Access Compliance Report

Public Rights-of-Way

(Pedestrian Signals)

Intersection ID: N/A	Main Street:	Cross Street: N/A	Location: N/A
ADA ID: 7E94AD3ACE52	Signal Type: Two Push Buttons-Non APS	Overall Compliance: No	Severity Score: BTN 1:N/A BTN 2: N/A No BTN: N/A
Codes/Mitigation Info/Possible Solution		Field Measurements/Component Compliance

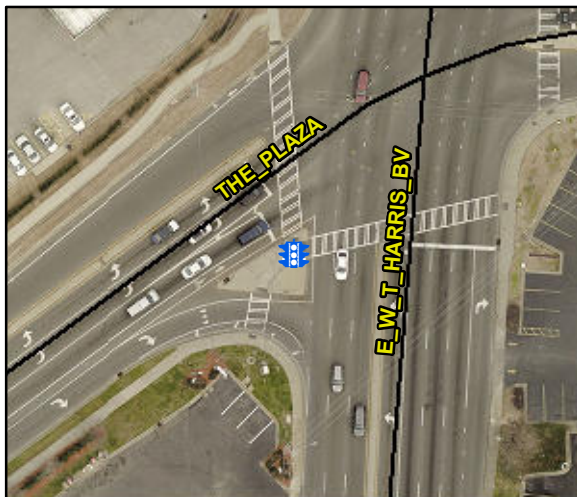
Surveyor Notes: TEXT HT 1/2

PROW/ADA: R410.6, R404.2, R406.2, R404.7.3, TMUTCD 4e.08

Compliance	Description	Data	Compliance	Description	Data
	Button Count	Button2	N/A	Distant to Additional Button (in)	N/A
	Additional Button Present?	N/A		Additional Button ID	N/A
N/A	Signal Buttons Required?	N/A	N/A	Additional Ped Posts Required	N/A
	How Many Ped Street Xings?	3		Located In An Island/Median?	Yes
N/A	B 1 Sign Present?	Yes	N/A	B 2 Sign Present?	Yes
Yes	B 1 Sign Purpose?	Yes	Yes	B 2 Sign Purpose?	Yes
No	B 1 Sign Lettering & Contrast?	No	No	B 2 Sign Lettering & Contrast?	No
Yes	B 1 Parallel To XWalk?	Yes	Yes	B 2 Parallel To XWalk?	Yes
Yes	B 1 PAR to Button?	Yes	Yes	B 2 PAR to Button?	Yes
Yes	B 1 PAR to XWalk?	Yes	Yes	B 2 PAR to XWalk?	Yes
Yes	B 1 Clear Floor Space?	Yes	Yes	B 2 Clear Floor Space?	Yes
N/A	B 1 FWD Approach?	Yes	N/A	B 2 FWD Approach?	Yes
N/A	B 1 FWD Approach Constrained?	No	N/A	B 2 FWD Approach Constrained?	No
No	B 1 FWD Approach Reach (in)	16.0	No	B 2 FWD Approach Reach (in)	15.0

N/A	B 1 FWD Approach Width (in)	N/A	N/A	B 2 FWD Approach Width (in)	N/A
N/A	B 1 FWD Approach Obstruction?	Yes	N/A	B 2 FWD Approach Obstruction?	Yes
N/A	B 1 FWD Approach Obstruction Dist (in)	4.0	N/A	B 2 FWD Approach ObstructionDist (in)	4.0
N/A	B 1 PARA Approach?	Yes	N/A	B 2 PARA Approach?	Yes
N/A	B 1 PARA Approach Constrained?	No	N/A	B 2 PARA Approach Constrained?	No
No	B 1 PARA Approach Reach (in)	16.0	No	B 2 PARA Approach Reach (in)	13.0
N/A	B 1 PARA Approach Width (in)	N/A	N/A	B 2 PARA Approach Width (in)	N/A
N/A	B 1 PARA Approach Obstruction?	Yes	N/A	B 2 PARA Approach Obstruction?	Yes
N/A	B 1 PARA Approach Obstruction Dist (in)	4.0	N/A	B 2 PARA Approach ObstructionDist (in)	6.0
Yes	B 1 Clear Floor Space Slope (%)	1.3	Yes	B 2 Clear Floor Space Slope (%)	0.7
No	B 1 Clear Floor Space XSlope (%)	2.3	No	B 2 Clear Floor Space XSlope (%)	3.5
N/A	B 1 PAR Slope (%)	2.8	N/A	B 2 PAR Slope (%)	2.8
Yes	B 1 Height (in)	41.0	Yes	B 2 Height (in)	41.0

Yes	B 1 Clear Xing Direction?	ClearlyMarked	Yes	B 2 Clear Xing Direction?	ClearlyMarked
	B 1 Crossing Direction	To NE		B 2 Crossing Direction	To NW
Yes	B 1 DistanceTo XWalk (in)	0.0	Yes	B 2 DistanceTo XWalk (in)	0.0
Yes	B 1 DistanceTo Curb (in)	69.0	No	B 2 DistanceTo Curb (in)	73.0
Yes	B 1 Diameter (in)	2.0	Yes	B 2 Diameter (in)	2.0

Possible Solutions: Remove & Replace Sign. Provide Push Button Extension. Remove and Replace Clear Space. Replace Signal Push Button With APS Button on New Post.
